## **DNJ ADDITION TO MOBILE SUBDIVISION**

Engineering Comments: FINAL PLAT COMMENTS (should be addressed prior to submitting the FINAL PLAT for review and/or signature by the City Engineer):

APPLICATION NUMBER 2 DATE February 2, 2017  
APPLICANT Mobile Subdivision, DNJ Addition to  
REQUEST Subdivision

# DETAIL SITE PLAN

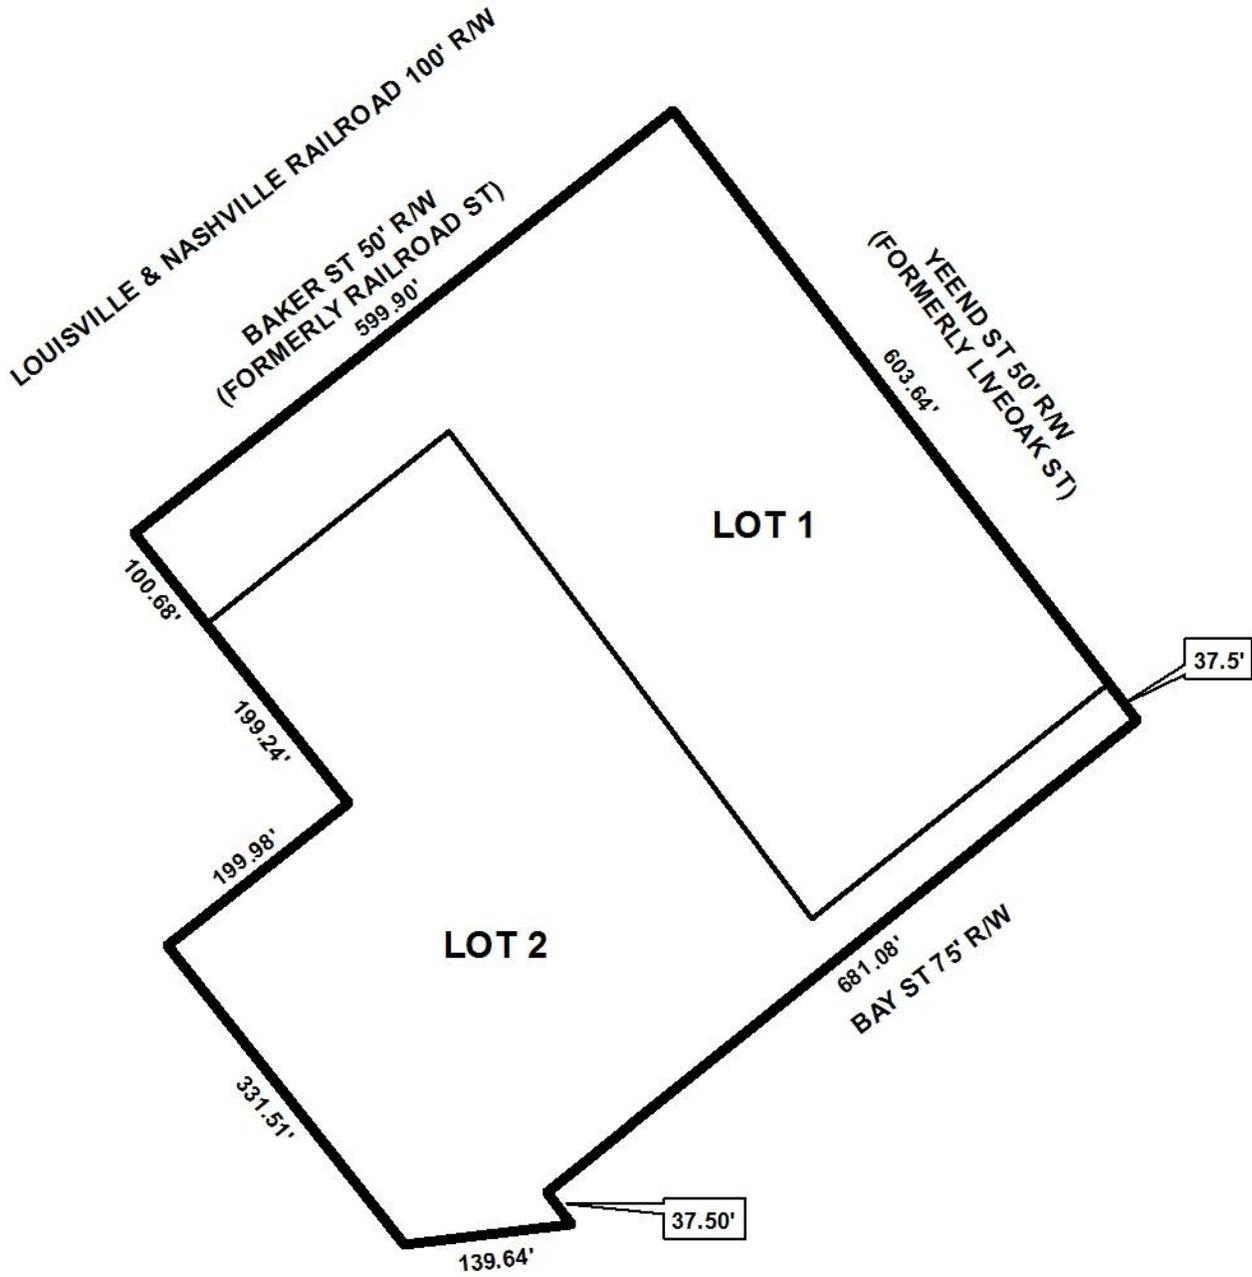
be revised to illustrate the minimum building setback line along Yeend Street as measured 65' from the centerline of Yeend Street (40' for possible widening and 25' for the setback from any future right-of-way after widening). The plat should also be revised to illustrate a 25' minimum building setback line along Baker Street as measured from the current right-of-way line. The plat should also be revised to illustrate the dedication of a 25' corner radius at the intersection of Baker Street and Yeend Street.

- 1) revision of the plat to illustrate a minimum building setback line of 65' as measured from the centerline of Yeend Street and the proposed Royal Street South major street;

- 2) revision of the plat to illustrate a 25' minimum building setback line along Baker Street as measured from the current right-of-way line;
- 3) revision of the plat to provide a 25' radius corner dedication at the intersection of Baker Street and Yeend Street;

- 4) placement of a note on the Final Plat stating that the subdivision is limited to its existing curb cuts, with size, location and design to be approved by Traffic Engineering and conform to AASHTO standards;

- 5) revision of the plat to label each lot with its size in both square feet and acres, after any required corner radius dedication for Lot 1, or the furnishing of a table on the Final Plat providing the same information;

*The revised plat indicates the minimum building setback line along Yeend Street as being 65' from the centerline of Yeend Street and the proposed Royal Street South major street, and as being 25' from the current Baker Street right-of-way. A 25' corner radius dedication is indicated at the corner of Baker Street and Yeend Street*

- 1) retention of the 40' minimum building setback line along Yeend Street as measured 65' from the centerline of Yeend Street and the proposed Royal Street South major street;*

- 2) retention of the 25' minimum building setback line along Baker Street as measured from the current right-of-way line;*
- 3) retention of the 25' radius corner dedication at the intersection of Baker Street and Yeend Street;*

- 4) placement of a note on the Final Plat stating that Lot 1 is limited to its existing curb cuts and Lot 2 is limited to one curb cut, with size, location and design to be approved by Traffic Engineering and conform to AASHTO standards;*

- 5) retention of the lot size labels on each lot with their sizes in both square feet and acres, after any required corner radius dedication for Lot 1, or the furnishing of a table on the Final Plat providing the same information;*
